City of Ketchum

Recommendation to hold a public hearing and approve the Condominium Subdivision Preliminary Plat for the Onyx at Leadville Residences.

**STAFF REPORT
KETCHUM CITY COUNCIL
REGULAR MEETING OF OCTOBER 21, 2019**

PROJECT: Onyx at Leadville Residences Condominium Subdivision Preliminary Plat

Exhibit B:
Condominium Subdivision
Preliminary Plat
dated August 2019

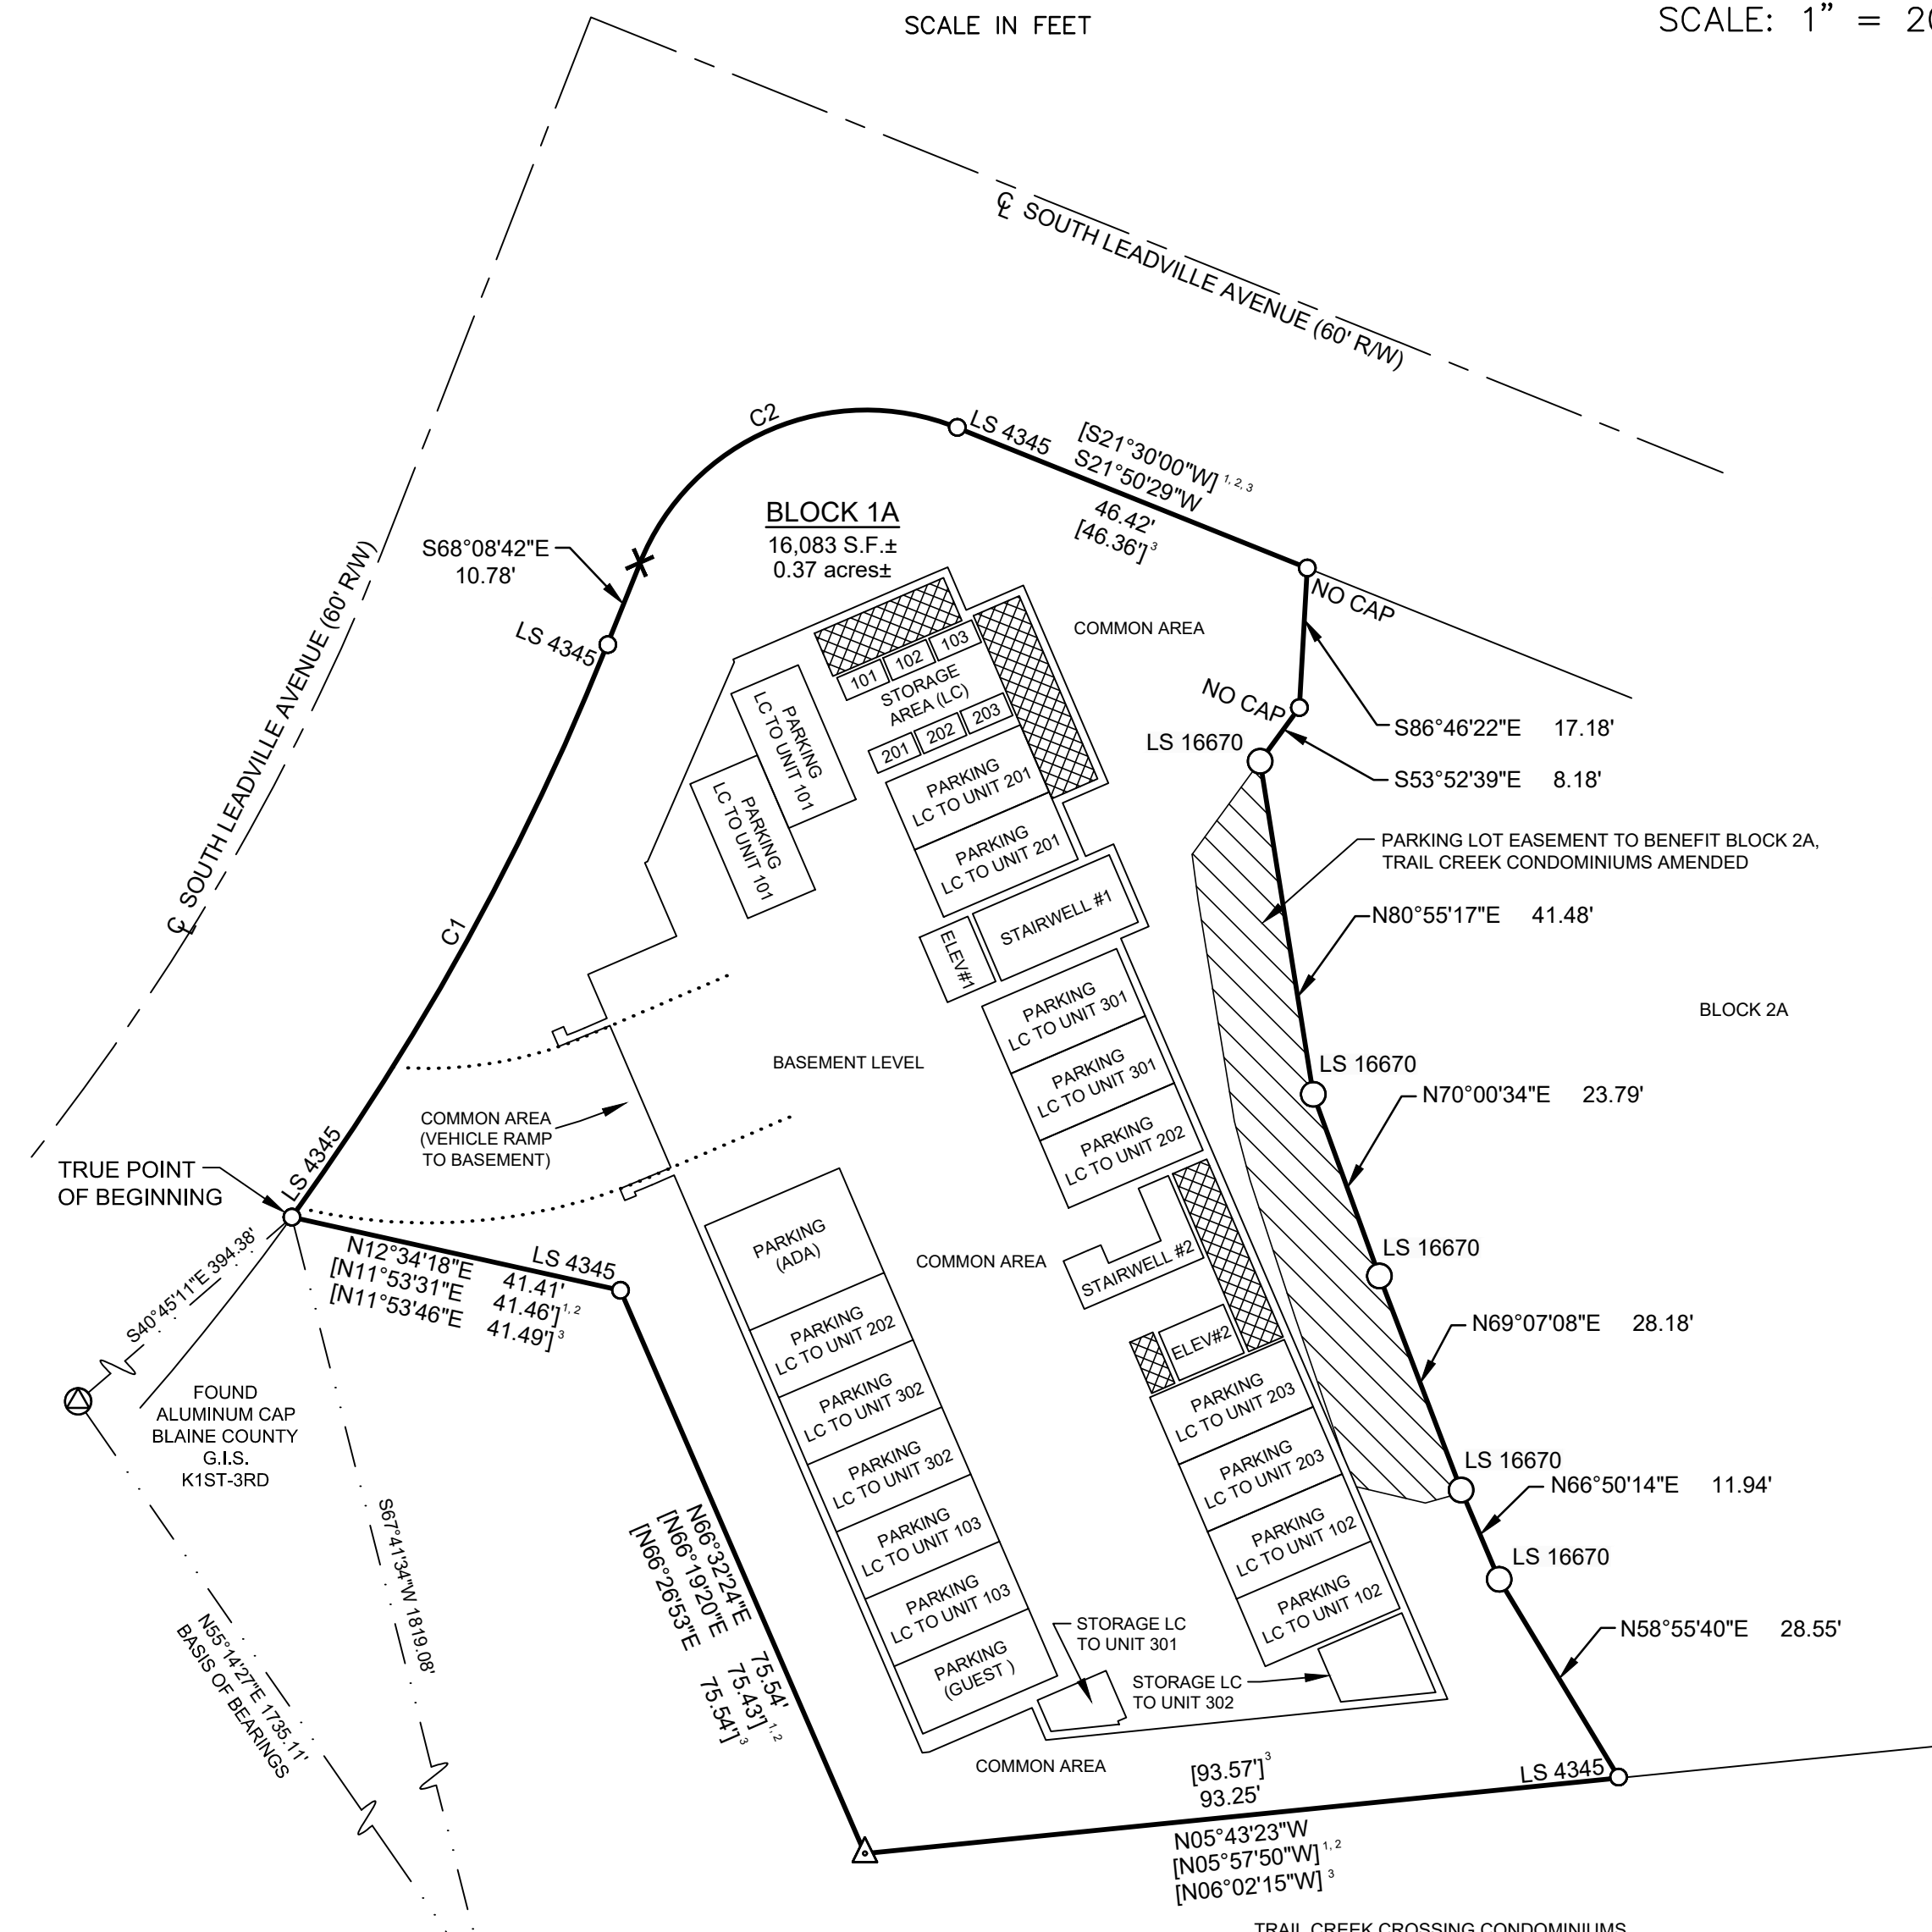
<p>Staff Comments <i>As noted in the City Engineer review comments attached as Exhibit C, the applicant shall include the required 5 ft utility easement on the Final Plat. As conditioned, the subdivision shall meet this standard.</i></p>
<input type="checkbox"/>	<input type="checkbox"/>	<input checked="" type="checkbox"/>	<p>16.04.040.K</p> <p>Sanitary Sewage Disposal Improvements: Central sanitary sewer systems shall be installed in all subdivisions and connected to the Ketchum sewage treatment system as a required improvement by the subdivider. Construction plans and specifications for central sanitary sewer extension shall be prepared by the subdivider and approved by the city engineer, council and Idaho health department prior to final plat approval. In the event that the sanitary sewage system of a subdivision cannot connect to the existing public sewage system, alternative provisions for sewage disposal in accordance with the requirements of the Idaho department of health and the council may be constructed on a temporary basis until such time as connection to the public sewage system is possible. In considering such alternative provisions, the council may require an increase in the minimum lot size and may impose any other reasonable requirements which it deems necessary to protect public health, safety and welfare.</p>

2. As noted in the City Engineer review comments dated October 9, 2019, the applicant shall include the following items on the Final Plat: (a) the 5 ft public utility easement as required pursuant to KMC §16.04.030.19, (b) certifications, (c) certificate of owner, (d) surveyor approval, and (e) agency approvals.
